SDCC Planning Response Report

St Edmundsbury – Strategic
Infrastructure Development (SID)
at Lucan, Co. Dublin

Re: RESPONSE TO AN COIMISIUN PLEANALA REQUEST, DATED 22 JULY 2026 (ACP REF. PA06S.324264) IN RESPECT OF THE PROPOSED STRATEGIC INFRASTRUCTURE DEVELOPMENT AT ST. EDMUNDSBURY HOSPITAL, LUCAN, CO. DUBLIN.

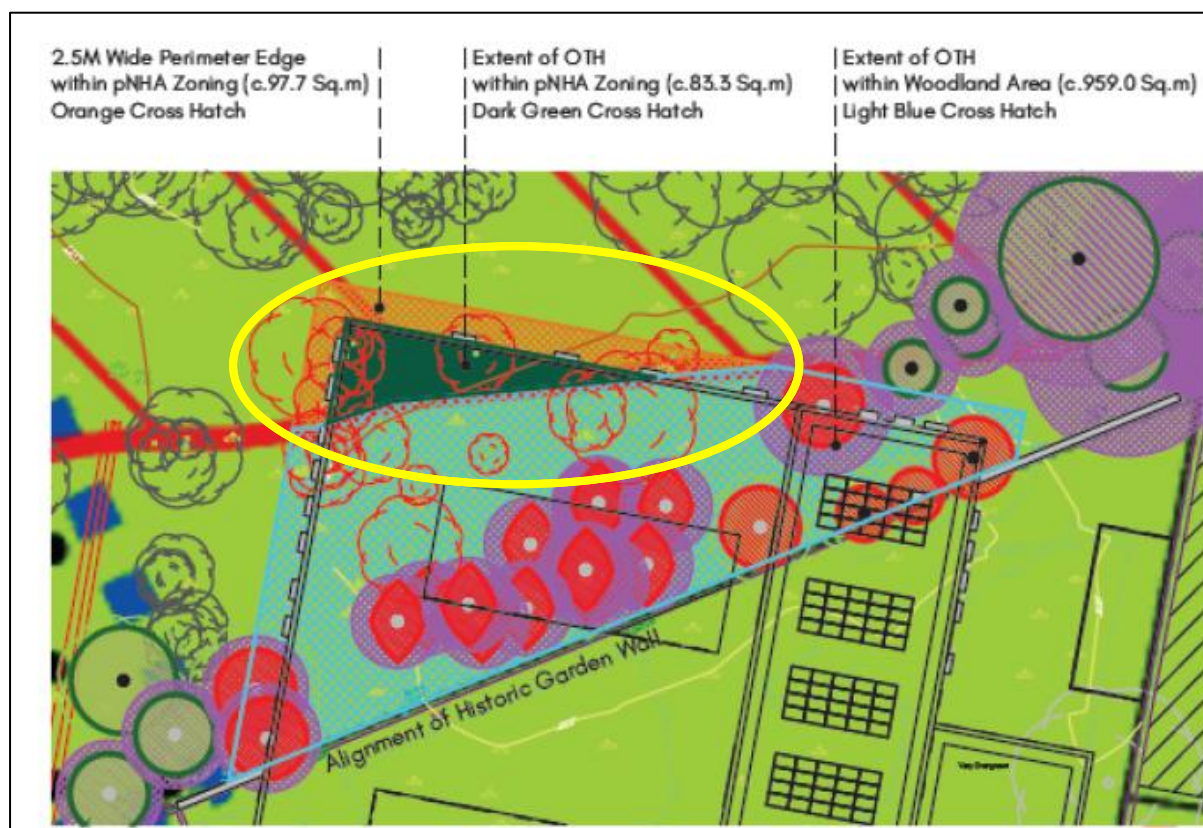
“The building footprint extends through the northern section of the walled garden into the existing woodland area through the centre of the site, reducing the amount of natural and soft landscape across the site. This section of woodland is part of the proposed Natural Heritage Area (pNHA) and the proposal represents an encroachment into a highly environmentally sensitive part of the site which the Planning Authority considers should be avoided through revised design and layout. The Planning Authority considers that further justification and design refinement is required. The overall design approach should be reconsidered including relocating building and hard surfaces away from this particularly sensitive part of the site.”

From the extract noted above, the extent of the proposed development within the pNHA has been carefully quantified and assessed. **The total area of encroachment within the pNHA amounts to approximately 181 m²**, comprising:

- 97.7m² of peripheral works within the pNHA (identified in figure 7.0 as the orange cross-hatched area), representing a c. 2.5m perimeter edge treatment which may be delivered as a permeable Grasscrete-type arrangement;
- 83.3m² of hard building element within the pNHA (identified as the dark green cross-hatched area).

Fig 2. Overlay of OTH Footprint onto Woodland & pNHA Zoning.

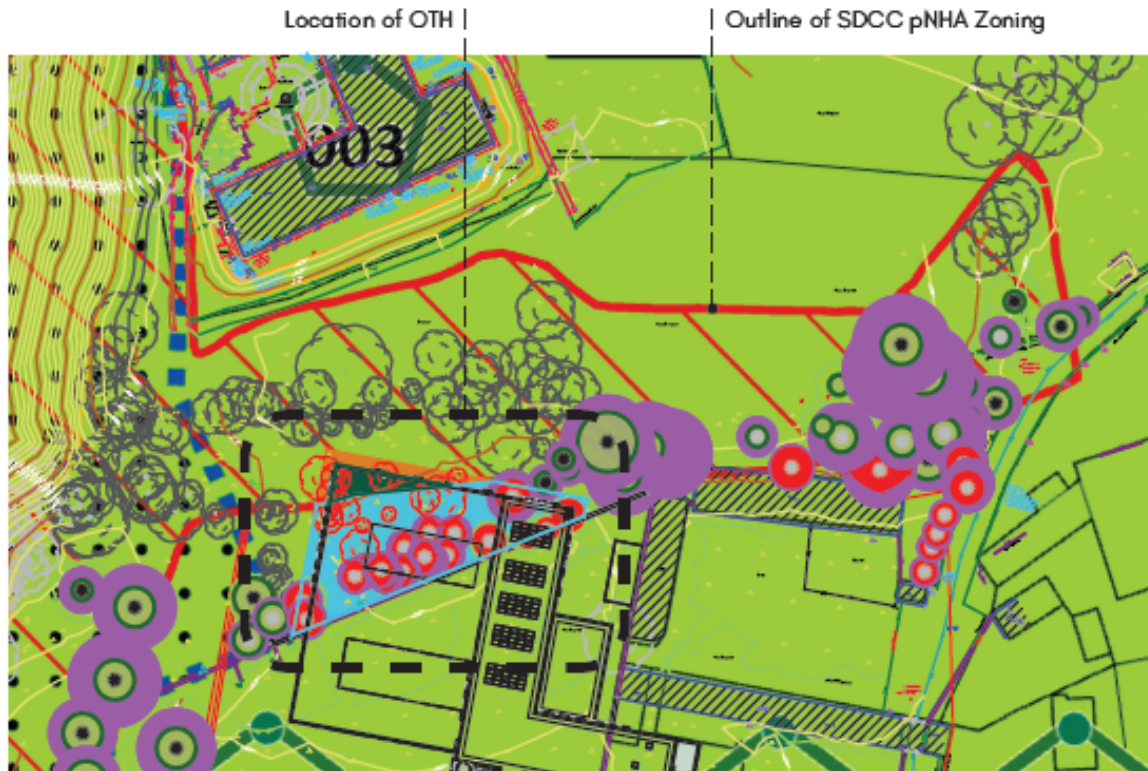
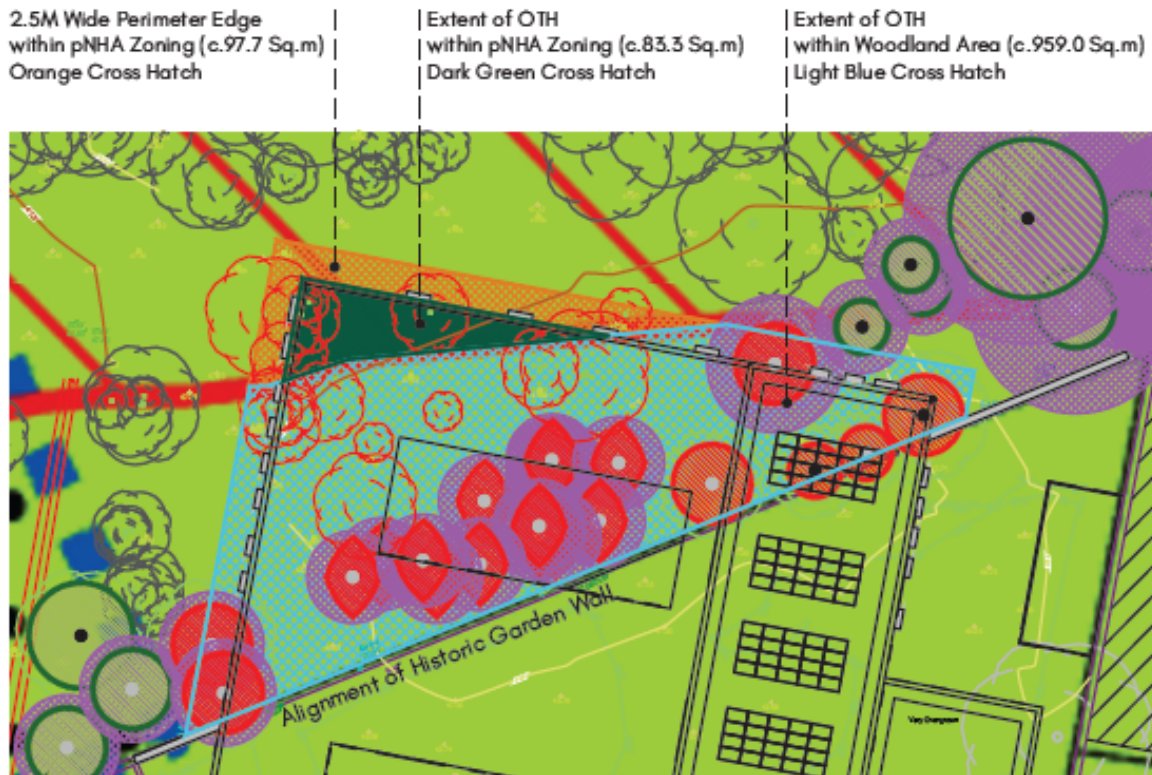
The SDCC Report then notes that the appended Heritage Officer Report makes recommendations for the proposed design to be amended in order to remove the intrusion of the north-western corner of the proposed development into the regenerated woodland buffer and pNHA woodland.

Early design stage responses to Saint Edmundsbury presented not only conservation and ecological challenges but also highlighted constraints on the viability of a wholly single-storey development. Consequently, the design process has prioritised the identification of core hospital functions that must be located at ground floor level, alongside those that could be accommodated at first floor level without adversely affecting the hospital's operation. This approach also balances operational requirements with site-specific constraints, such as building height and visual impact considerations. It also aims to avoid replicating the operational complexities experienced within the SPMHS James' Street facility, which originated from its historical multi-storey context, within a tight urban setting and decades of unstructured ad hoc expansion. Further, in an era where mental health design was not considered beyond that of a general hospital environment with shared ward arrangements, the current and necessary standard provides for single bedroom / en-suite arrangements, thus requiring more space provision.
